STATE OF NORTH CAROLINA  
FAYETTEVILLE STATE UNIVERSITY  
PURCHASING DEPARTMENT  
<http://www.uncfsu.edu/fsubo/purchasing>

## Solicitation Addendum

**Solicitation Number:** 58-RFP260003

**Solicitation Description:** Professional Audio and Visual Equipment and Installation Services for COE

4 65" Rear Wall Display and Camera Elevation  
NTS

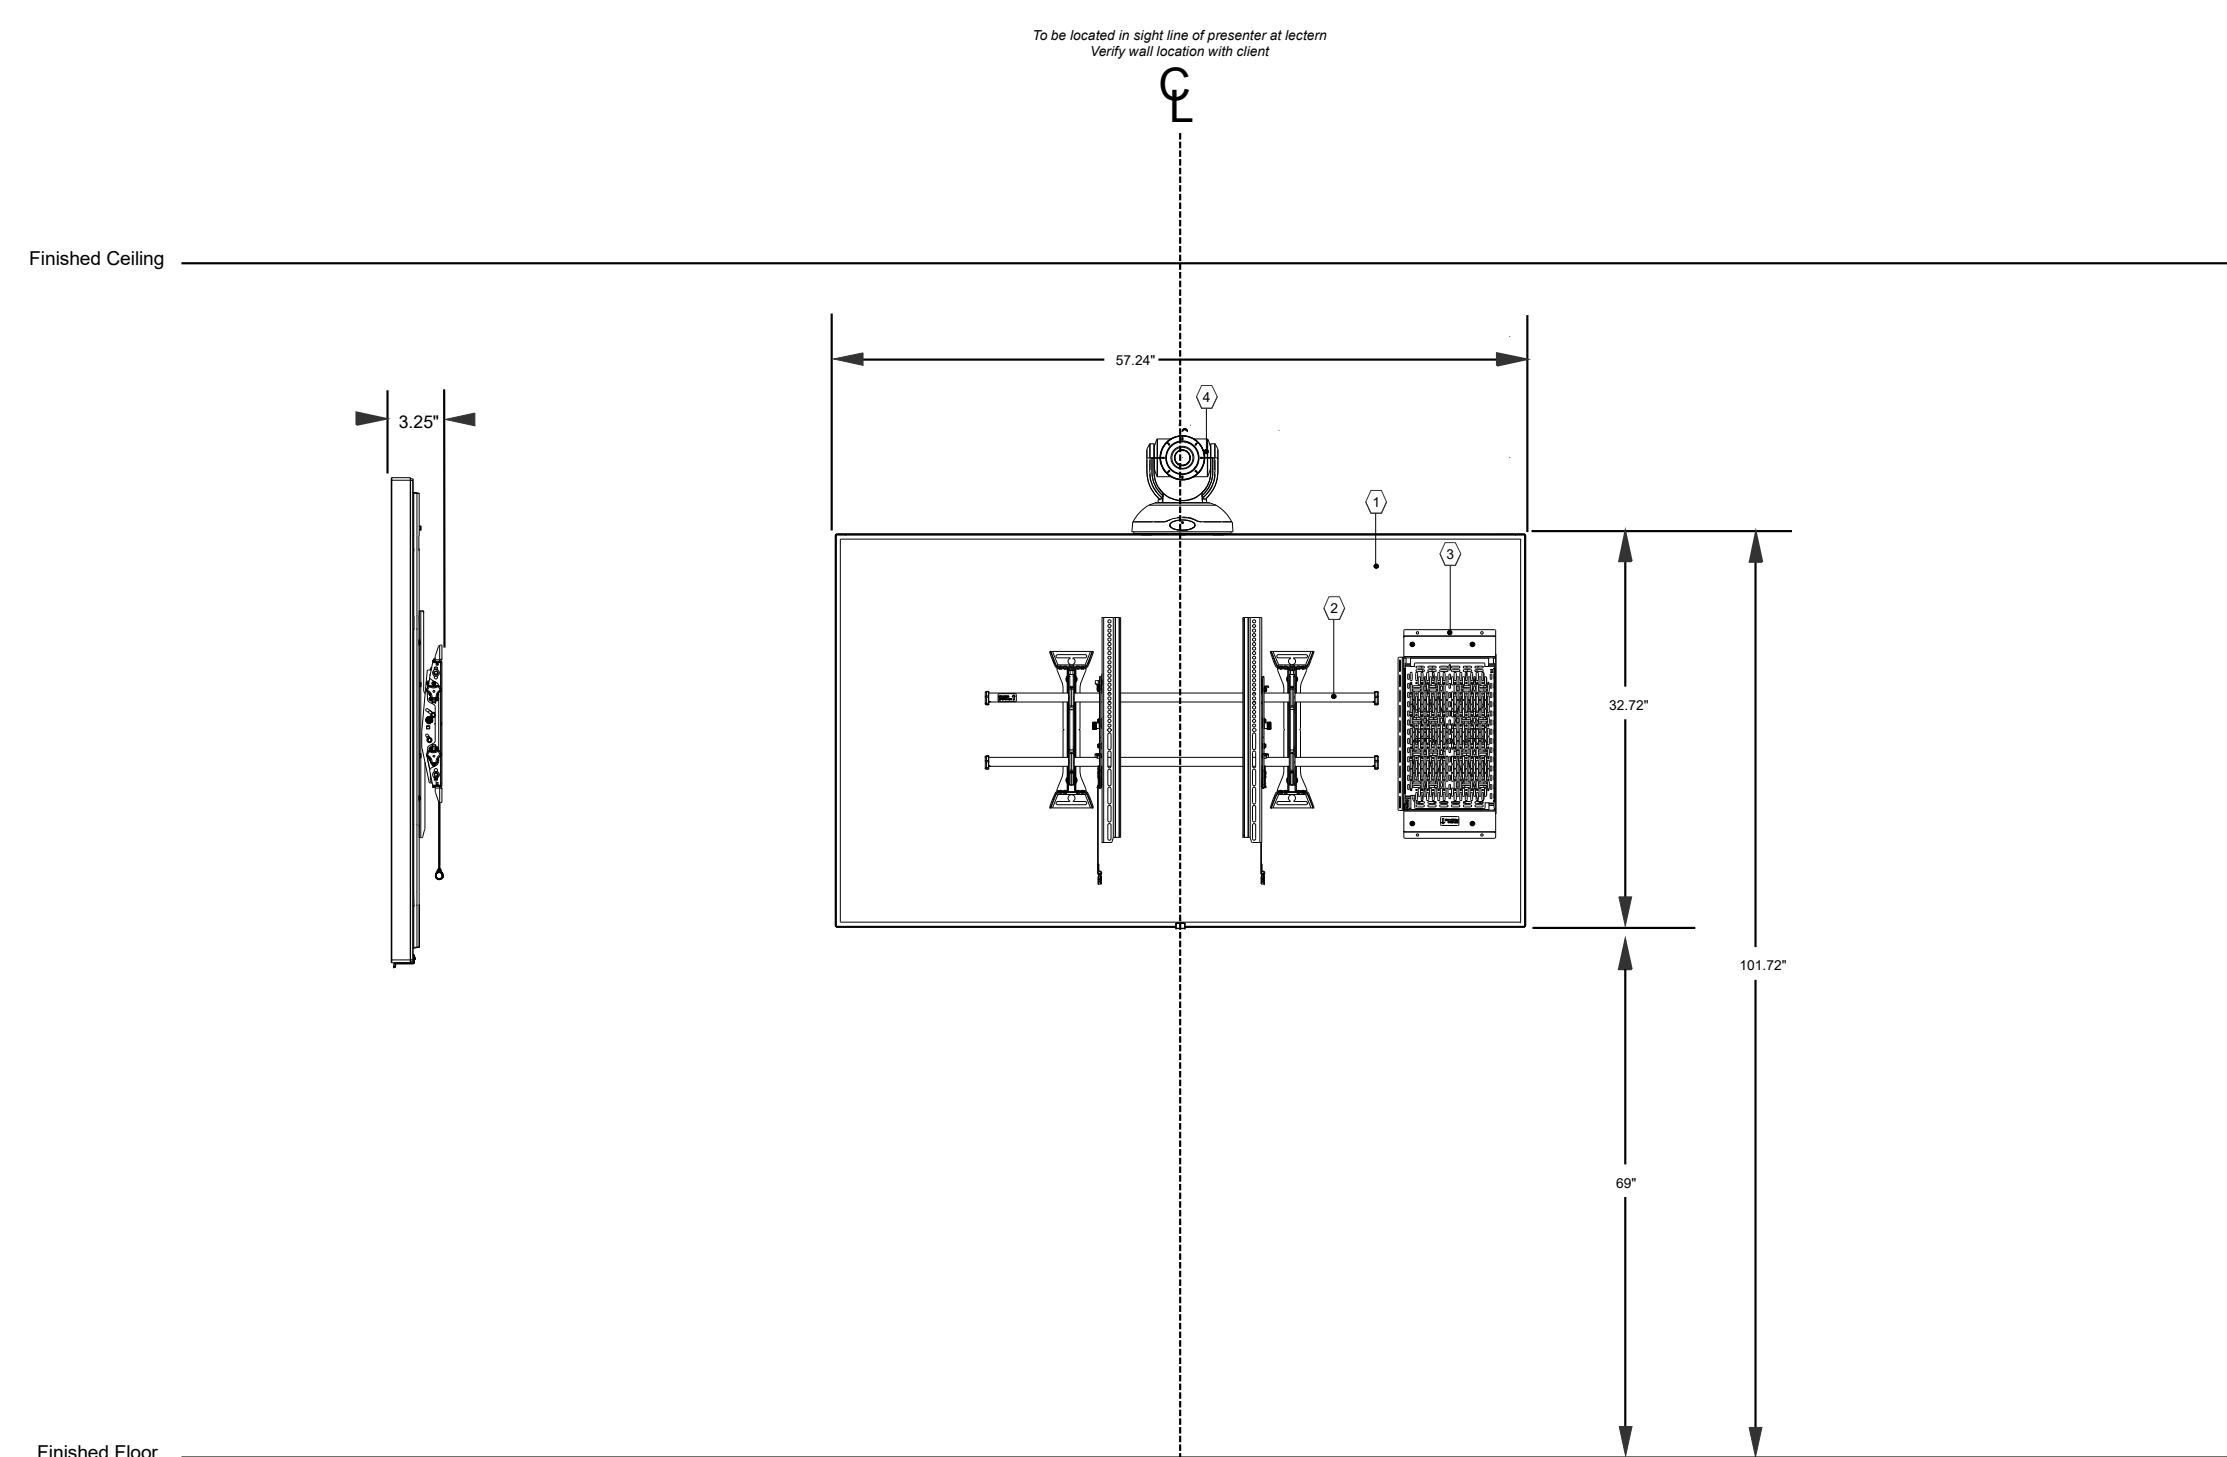
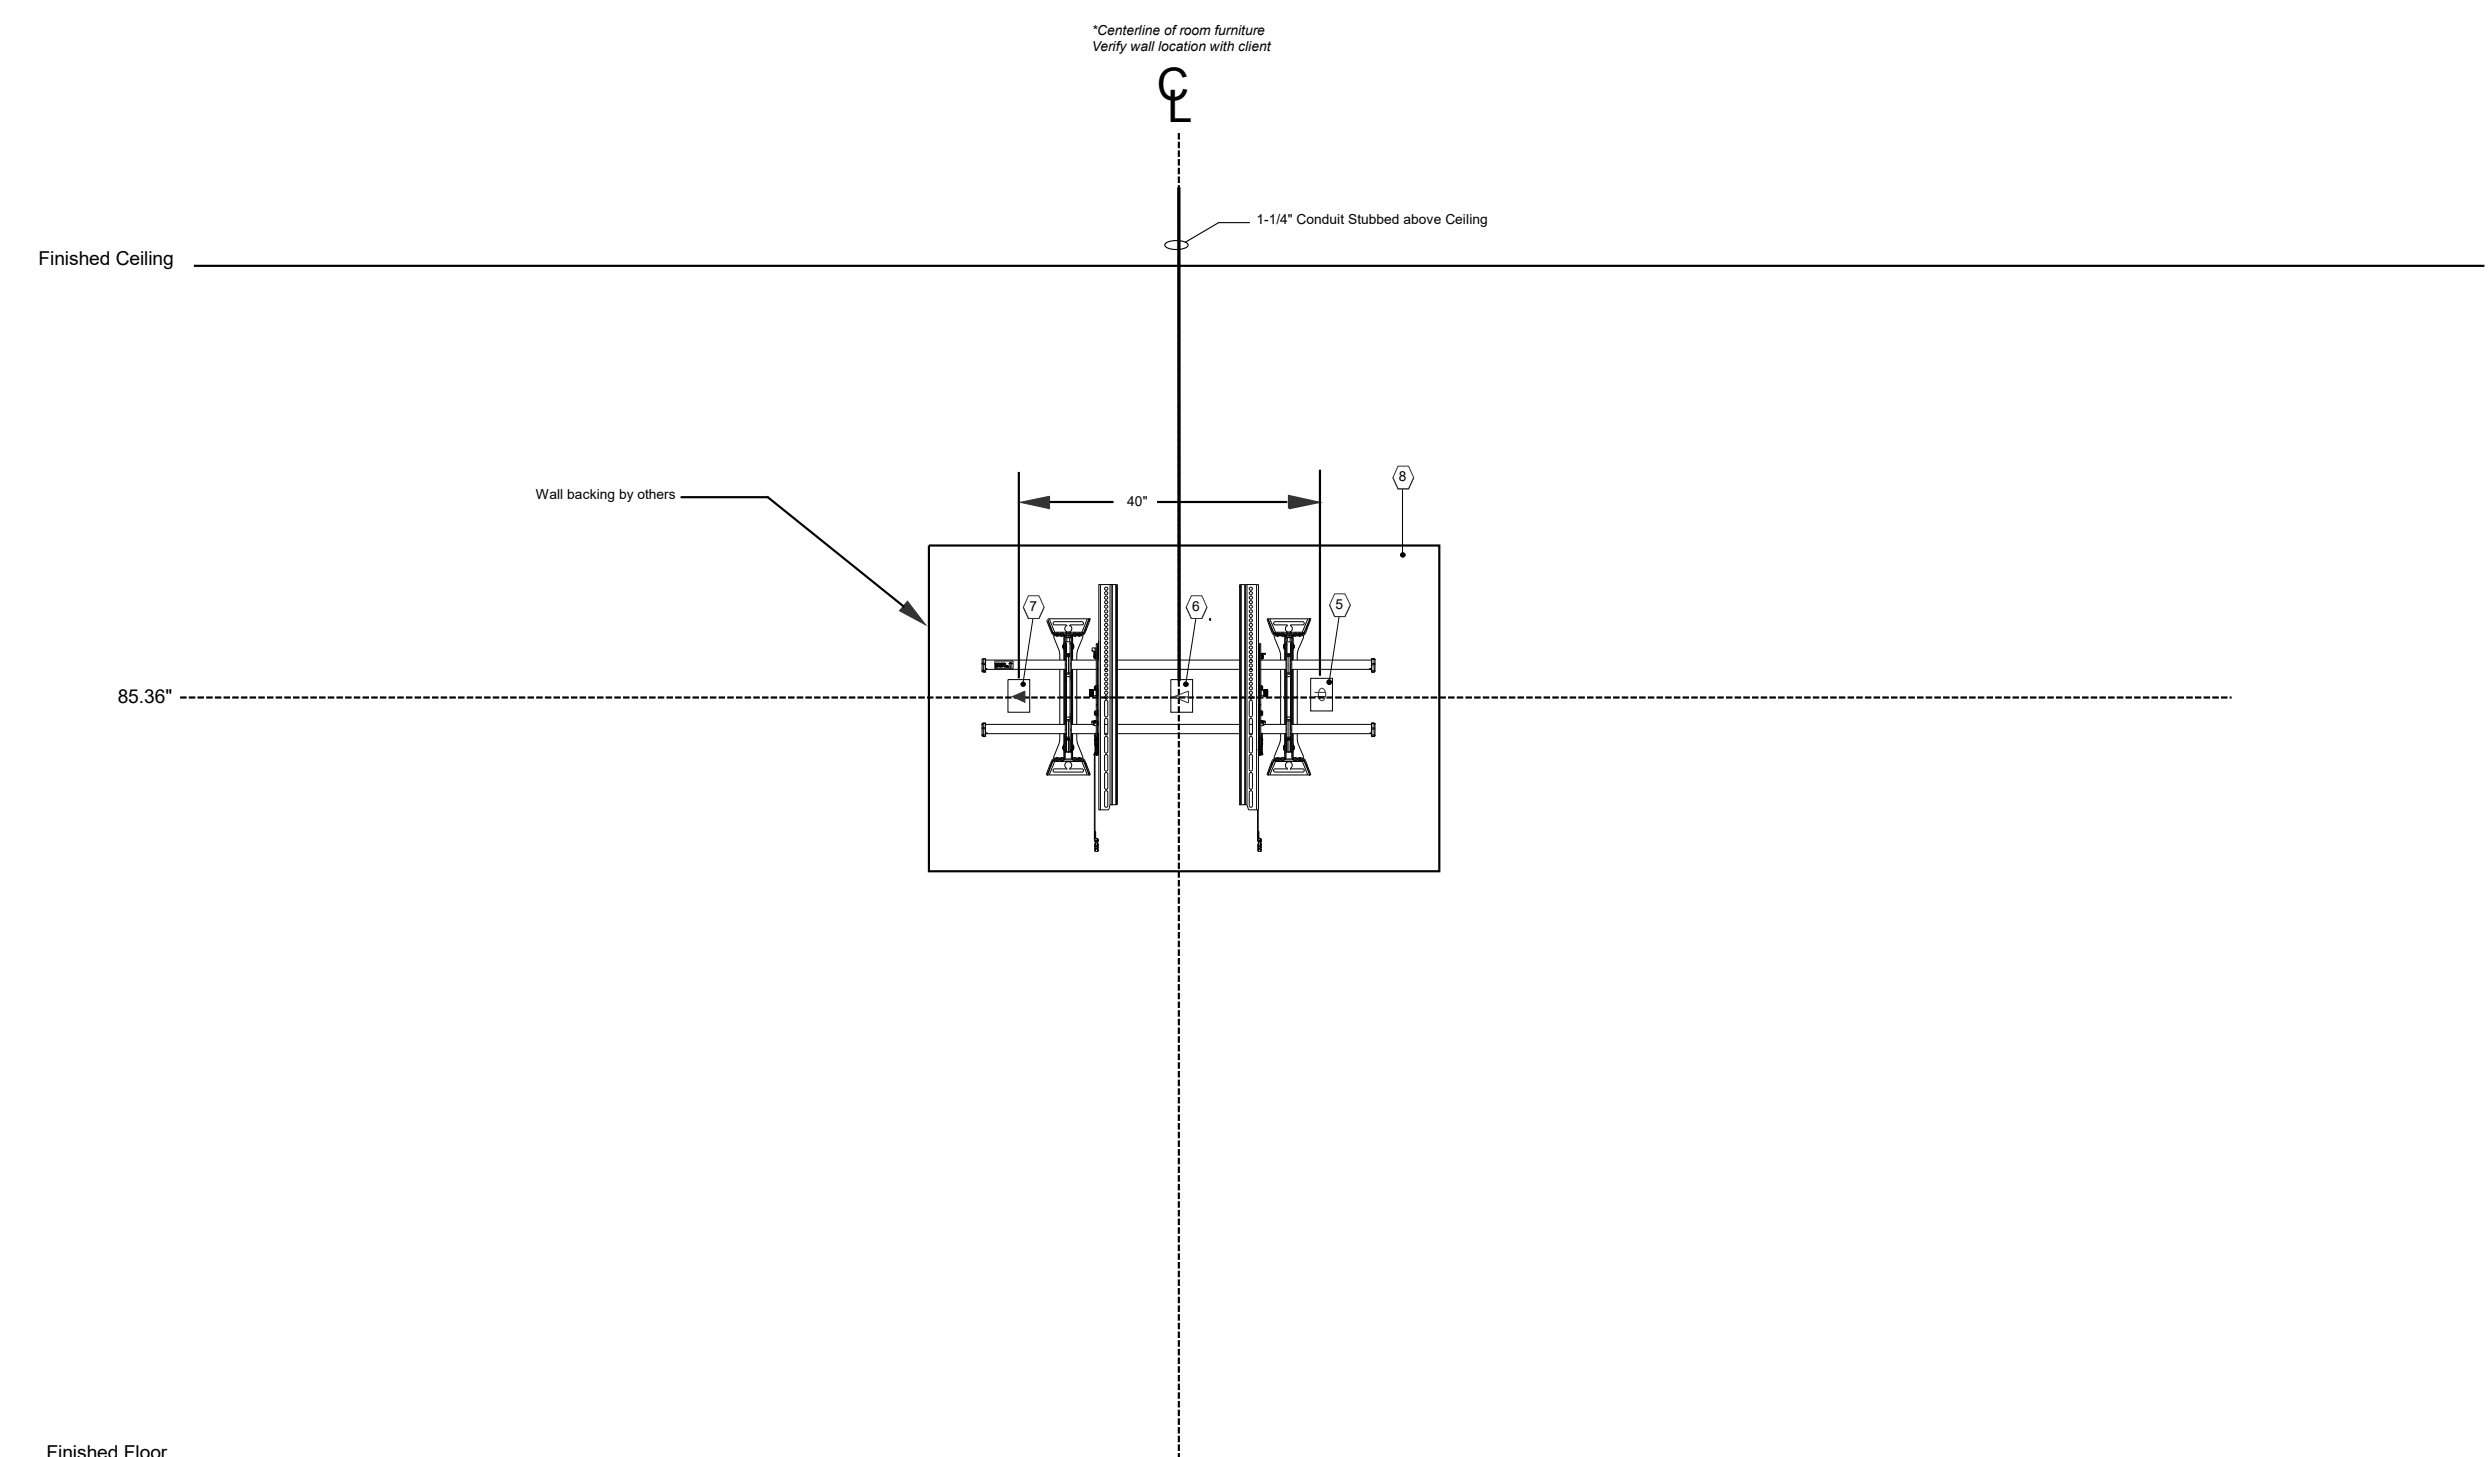
22	Design	<p>The drawings show corridor displays as 42" displays but during the walk-through it was mentioned that all Elevator Lobby displays should be 65". Does this apply to all corridor displays (ie. CORR C-109)?</p> 	<p>Yes, this was a change please move all to 65".</p>
23	Design	<p>There is a TP symbol near VEST 100. What is this used for?</p> 	<p>Reference drawing sheet T001 for "TP " symbol description.</p>
